#### Level 5 t+61 2 9320 9320 151 Clarence Street f +61 2 9320 9321 Sydney NSW 2000 d +61 2 9320 9198 Australia www.arup.com Job number Project title WSU Bankstown 263785-00 File reference CC Kurt Freeburn Date Prepared by Sophie Zachulski / Vanessa Ly-Dam 6 July 2020 Subject Gateway Determination - Further Traffic Considerations

Arup has prepared this note to summarise the additional traffic assessment undertaken to satisfy the conditions of the Gateway Determination for the Planning Proposal. This note supplements the Transport Management and Accessibility Plan (TMAP) for the proposed WSU BCC Development in July 2019.

Table 1: Peer review recommendations relating specifically to traffic modelling

Figure 1: Peer Review distribution comments

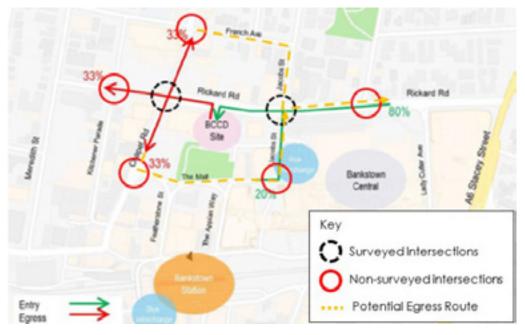
The Peer Review noted that a wider traffic assessment was not conducted across the area. The TMAP considered a robust traffic generation and traffic distribution development scenario, based student current catchment and car parking assessment across the road network. The outlined intersections that the Peer Review noted are provided in Figure 1.

It was noted that no traffic surveys or modelling has been undertaken at the above intersections. The above intersections are circled red, with the surveyed intersections shown in black in the following figure. It is noted that the intersection impacts at the Rickard Road-Jacobs Street intersection could potentially be exacerbated as a result of motorists (egress) wishing to turn back onto Stacey Street, as shown in orange dashed line below.

In line with the recommendation in the Peer Review, the extent of modelled intersections for an existing year scenario (2018) has been increased to include the following signalised intersections:

- Rickard Road / Sir Joseph Banks Street.
- Rickard Road / Kitchener Parade; and
- French Avenue / Chapel Road.

Given the current restrictions imposed by the COVID-19 outbreak, traffic surveys are unlikely to be representative of typical traffic patterns. Therefore, to inform the existing level of traffic on these intersections, SCATS data from September 2018 (the same time period of data collected for the previous models) was used. As such, no intersection count data is available at the priority intersections south of the site, but site observations in 2018 undertaken as part of the TMAP indicated that there was minimal delay at these sites.
